D7.7.1 Xerox® AltaLink® Product Enhancement Document for Version 119.xxx.023.13000

Description of new features and enhancements to the products specified below.

Release Date: June 30,2023

Edit Login Methods

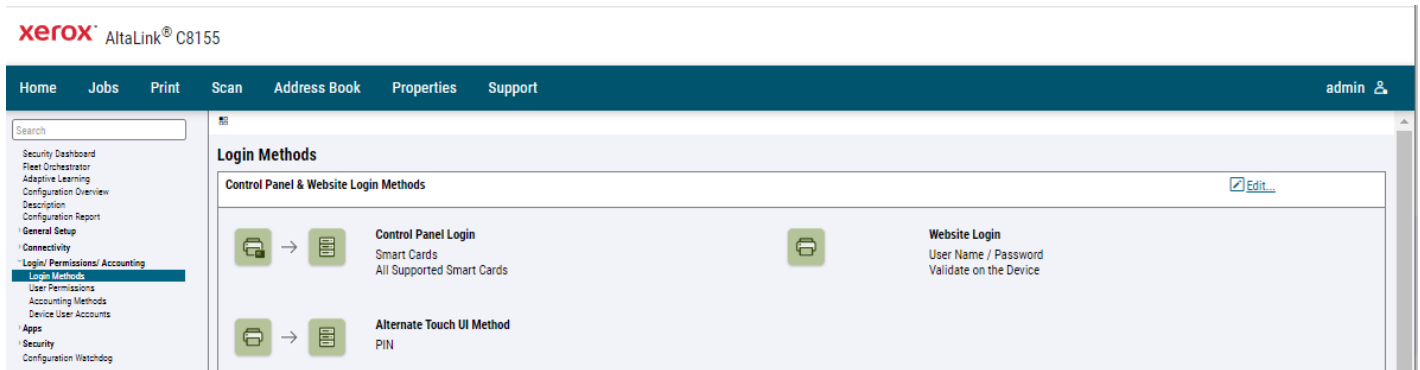
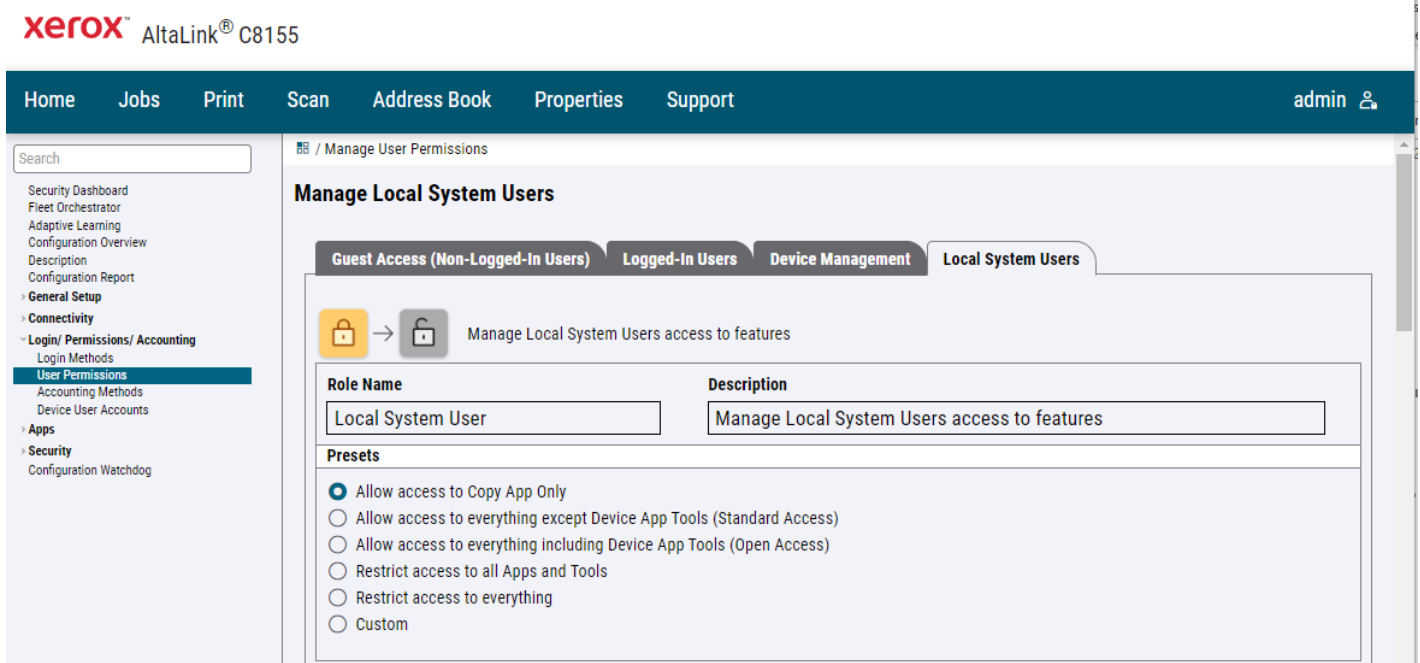
1. Enable Local System User Login for Apps

For Smartcard or Convenience Authentication, the SA will be able to configure apps that the Local System User can access.

1. Set the Control Panel Login to either Smartcards or Convenience Authentication.
2. Edit On-Device Authentication and slide to enable.
3. When using Smartcards, set the Alternate Control Panel Login to Local System User Login.
